RESPONSE TO REQUEST FOR ADDITIONAL INFORMATION

APR1400 Design Certification

RAI No.: 116-8054

SRP Section: 14.03.08 – Radiation Protection Inspections, Tests, Analyses, and Acceptance Criteria

Table 2.8-2

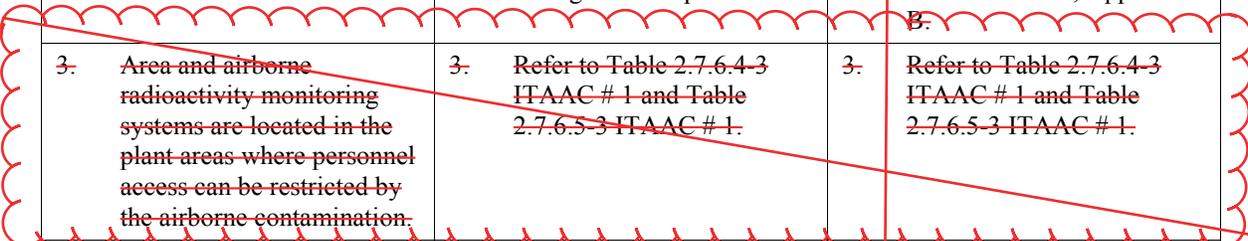
1. Item 2 in Table 2.8-2, indicates that an analysis will be performed to ensure that airflow is from areas of lower potential airborne contamination to areas with higher potential airborne contamination. The acceptance criteria states, "Analysis exists and concludes that ventilation airflows are from the lower potential airborne contamination area to the higher. The concentrations of airborne radionuclides are in the limit specified in 10 CFR Part 20, Appendix B." Staff believes that the intent of the acceptance criteria is to say that an analysis exists and concludes that ventilation airflow in radiological controlled areas flows from areas of lower potential airborne contamination to areas of higher

potential airborne contamination and that the concentrations of airborne radionuclides shall not exceed the concentrations provided in 10 CFR Part 20, Appendix B. Please revise the acceptance criteria, as appropriate.

2. Item 3 in Tier 1, Table 2.8-2 refers to other ITAAC in Tier 1 Tables 2.7.6.4-3 and 2.7.6.5-3 and is confusing to staff. It does not appear to provide any new acceptance criteria or requirements beyond what is provided in Tier 1, Tables 2.7.6.4-3 and 2.7.6.5-3. Please explain why item 3 in Table 2.8-2 is necessary or delete it.

1. The acceptance criteria for ventilation systems for the radiological controlled areas, ITAAC Item 2 in Table 2.8-2, will be revised to state that an analysis exists and concludes that ventilation airflow in radiological controlled areas flows from areas of lower potential airborne contamination to areas of higher potential airborne contamination. The concentrations of airborne radionuclides shall not exceed the concentrations provided in 10 CFR Part 20, Appendix B.
2. ITAAC Item 3 in Table 2.8-2 will be deleted since it is repetitive to other ITAAC in Tier 1 tables and does not provide any new acceptance criteria or requirements.

DCD Tier 1 Table 2.8-2 will be updated as indicated in the Attachment.

Analysis exists and concludes that ventilation airflow in radiological controlled areas flows from areas of lower potential airborne contamination to areas of higher potential airborne contamination. The concentrations of airborne radionuclides shall not exceed the concentrations provided in 10 CFR Part 20, Appendix B.
